Access Compliance Report

Public Rights-of-Way

(Curb Ramps)

Intersection ID: 11541	Main Street: W_9TH_ST	Cross Street: N_PINE_ST	Location: N
ADA ID: 52F878FCE960	Ramp Type: PerpDiag	Initial Pass/Fail: Fail	Overall Compliance: No
			Severity Score: 13.75

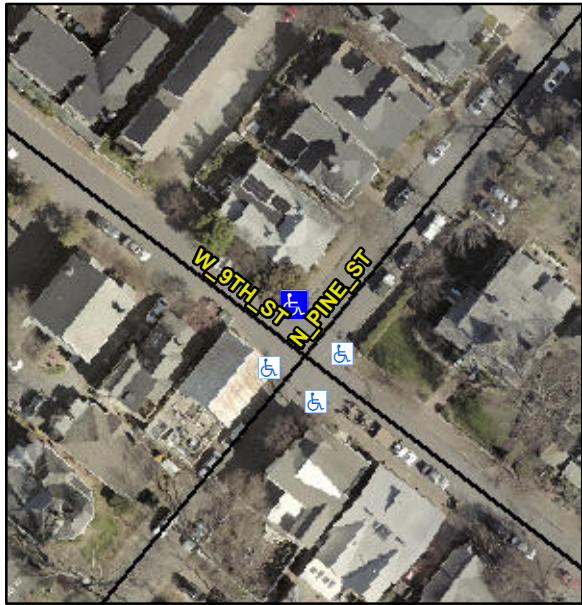
Codes/Mitigation Info/Possible Solution			Field Measurements/Component Compliance					
	Possible Solutions:		Compliance	Description	Data	Compliance	Description	Data
	Remove & Replace Curb Ramp With Two New Directional Ramps or Equivalent.		N/A	Ramp Length (in)	58.0	No	Ramp Slope (%)	11.7
			Yes	Ramp Width (in)	72.0	No	Ramp XSlope (%)	3.1
			N/A	Flare Type LT	N/A	N/A	Flare Type RT	N/A
			N/A	Flare Slope LT (%)	N/A	N/A	Flare Slope RT (%)	N/A
			N/A	Flare Traversable LT?	N/A	N/A	Flare Traversable RT?	N/A
			N/A	Landing Length (in)	N/A	N/A	DWS Provided?	N/A
			N/A	Landing Width (in)	N/A	N/A	DWS Contrast?	N/A
			N/A	Landing Slope (%)	N/A	N/A	DWS Length (in)	N/A
			N/A	Landing X Slope (%)	N/A	N/A	DWS Full Width?	N/A
Surveyor Notes:			N/A	Landing Curb? (Y/N)	N/A	N/A	DWS Offset (in)	N/A
N/A			N/A	Shared Landing?	N/A			
PROW/ADA:			N/A	Gutter Ponding?	N/A	N/A	Gutter Slope (%)	N/A
Not Found, R304.2.2, R304.5.3			N/A	Gutter Lip Ht (in)	N/A	N/A	Gutter X Slope (%)	N/A

N/A	Painted X Walk1?	No	N/A	Painted X Walk2?	No
				X Walk 1 Direction	To SW		X Walk 2 Direction	To SE
			N/A	X Walk 1 Width (in)	N/A	N/A	X Walk 2 Width (in)	N/A
				X Walk 1 Slope (%)	9.2		X Walk 2 Slope (%)	6.8
				X Walk 1 X Slope (%)	4.8		X Walk 2 X Slope (%)	0.4
			N/A	Ramp inside XWalk1?	N/A	N/A	Ramp inside XWalk2?	N/A
				Road Slope (%)	2.3	N/A	Clear Space?	N/A
				Road X Slope (%)	9.1	N/A	Clear Space to XWalk (in)	N/A
			N/A	Any Obstructions?	N/A	N/A	Storm Grate/Utility Hazard?	N/A
				Obstruction Type			Storm Grate/Utility Type	
					N/A			N/A
						Yes	Surface Condition? (G/P)	Good
Street 1 Name		W 9TH ST						
Stop Condition-Street 2		None						
Street 2 Name		N PINE ST						
Stop Condition-Street 1		StopSign						
Total Cost:		\$ 3200.00
